Data reuse justification letter

Re: New application FCC ID: RC6-GRN72C

This application is intended to reuse previous test data (from FCC ID: RC6-GRN70C, certified on 01/06/2020), due to the fact that the two versions of products are hardware-wise identical and only the following changes have been made:

Original FCC ID: RC6-GRN70C

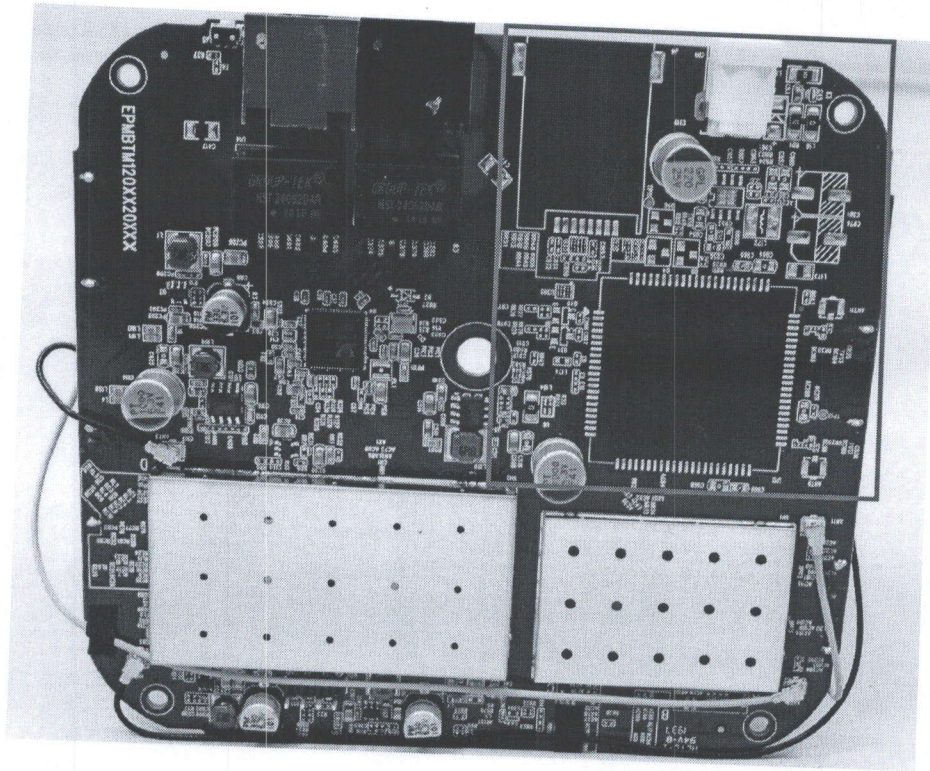
1. **Remove LTE hardware:** There are a total of two PCB boards, and ZigBee is located on first PCB board as shown below.

New FCC ID: RC6-GRN72C: all LTE related components removed.

Since LTE circuit are located in an isolated block with all RF circuits shielded and have its own independent antenna, so, no big impact on the 2.4G, 5G non-license circuit is expected. We have performed spot checks on the following items to verify that if any unexpected RF conducted power or emission changes can be noted. The test results show that all spot check data are within the instrument measurement uncertainty and data reuse is justifiable.
